Consultation on options to improve cycling connections in the eastern suburbs and to the city

Re: Options to improve cycling connections in the eastern suburbs and to the city [Options for Evans Bay Parade, Kilbirnie connections, Miramar connections, and Miramar Avenue (Tauhinu Road to Park Road)]

This submission is from the Architectural Centre, an incorporated society dating from 1946, which represents both professionals and non-professionals interested in the promotion of good design.

Island Bay cycle way bus stop causing cyclist diversion

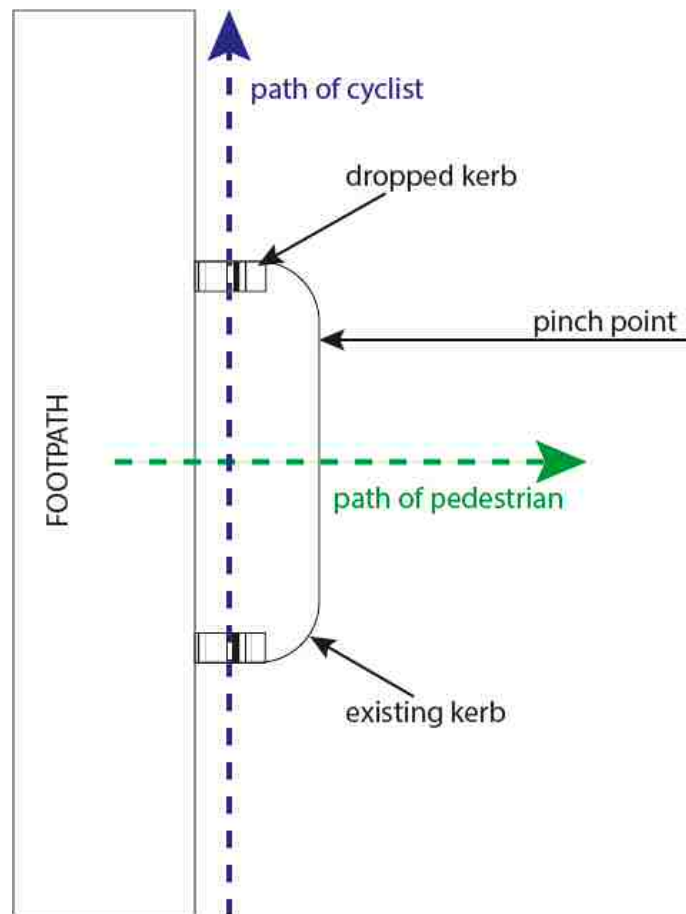
7. Equally, **how bus stops are to be incorporated** (e.g. Rongotai Road) is absent from the designs. These should not interrupt the straight path of a cyclist, requiring cyclists to have to deviate around buses and passengers (as in the Island Bay cycleway design),

but instead should be designed like this one in Brighton, England ...

Cycleway and bus stop design, Brighton, England showing levels and kerbing distinguishing road space from pedestrian space, and the gradual curve to the cycleway to accommodate a bus stop island (also note the lack of driveways disrupting the cycleway).
